Access Compliance Report Public Rights-of-Way (Curb Ramps)

Main Street: RANCHO_SANTIAGO_BLV		Cross Street: E_AVENIDA_PALMAR		Location:	NE
ADA ID: RPRK211223122049	Ramp Type: Type 4 - Parallel	Initial Pass/Fail: Fail	Overall Compliance: No	Severity Score:	16
Codes/Mitigation Info/Possible Solution			Field Measurements/Component Compliance

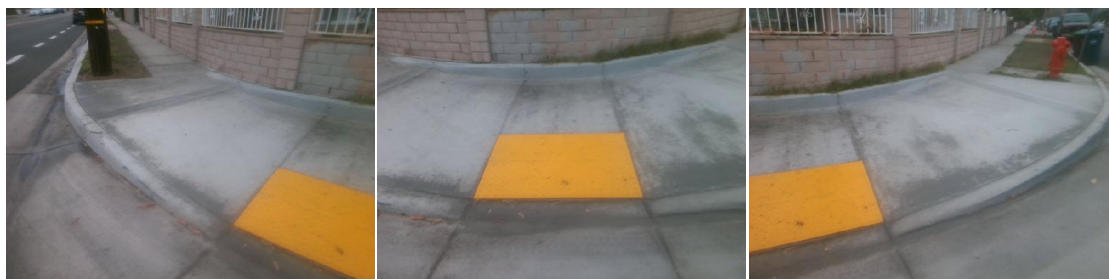
R304.5.3, R304.3.2, STD 1115

Remove & Replace Curb Ramp With Two New Directional Ramps or Equivalent.
